P 544484

**ON-SITE SEWAGE DISPOSAL SYSTEM  
HOWARD COUNTY HEALTH DEPARTMENT  
BUREAU OF ENVIRONMENTAL HEALTH**

SUBDIVISION: Holly House Meadows LOT NUMBER: 8

ADDRESS: 8108 Holly Manor Way PROPERTY OWNER: Cornerstone Homes Inc.

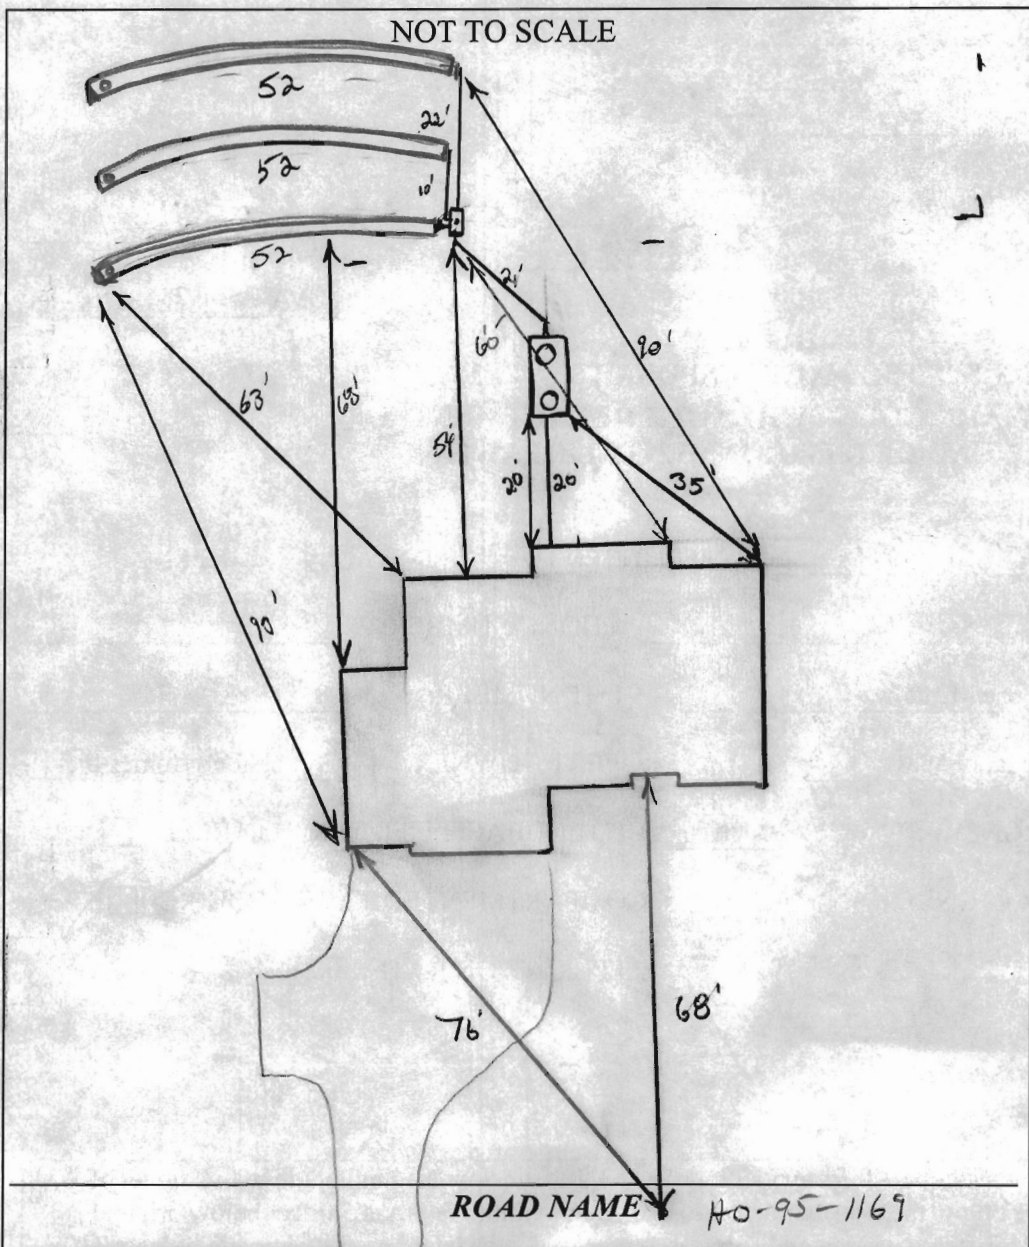
8/21/13 stakes missing to SRA. Trees/shrubs/bamboo needs to be cut down w/in septic reserve area prior to any layout. OK to set tank 20' from house. sewer under footer! shot elev. @ sewer in/out of house, grade @ tank. should be OK. 2.5' cover, w/ 1% fall. Call when SRA is staked and area cleared. (PW)

8/29/13 Septic area cleared, SRA re-staked, confirmed corners w/ house. S.T. set per layout. Had to cut outlet pipe to 3' max. SHC plumbing ran. 9/3/13 Dbox set. Nesting done completely. 9/5/13 septic complete. D box installed. OK to cover all work. (PW)
